INSTRUCTION TO SERVICE

ITS: 61756		DATE 06/08/2026
SECTION:	231 – Cooling System	
SUBJECT:	Hybrid System Cooling Pump Replacement	
ISSUE:	Pump shuts off for a brief 9-10 seconds due to an internal firmware issue.	
SUMMARY:	Instructions to remove OEM pump and replace with a pump with updated firmware

Figure 3: Install New Coolant Pump

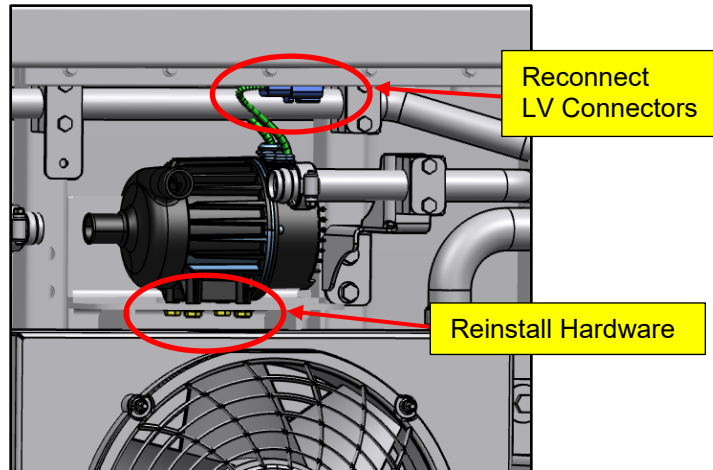
9. Replace the existing pump with the new coolant pump.
10. Set the removed coolant pumps aside and send them back to supplier. Reach out to RPSM for shipping instructions and details.
11. Reuse hardware, apply loctite-243 and torque to 9-10 ft-lbs.
12. Connect low voltage connectors of the pump to HRNS-INV ROOF RACK connectors, VEPI/DTI CLNT PUMP-XCCCAN and VEPI/DTI CLNT PUMP-TWR.

Figure 4: Reconnect Coolant Hoses

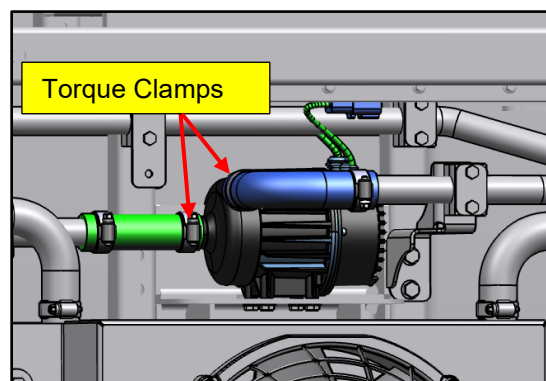
13. Reconnect coolant supply and return coolant hoses to the new pump.
14. Torque ideal wavyseal clamps (NF PN: 553153) to 80 in-lbs, dry. Tighten at 75 rpm or less, re-torque to 80 in-lbs at 75 rpm or less after 30 minutes.
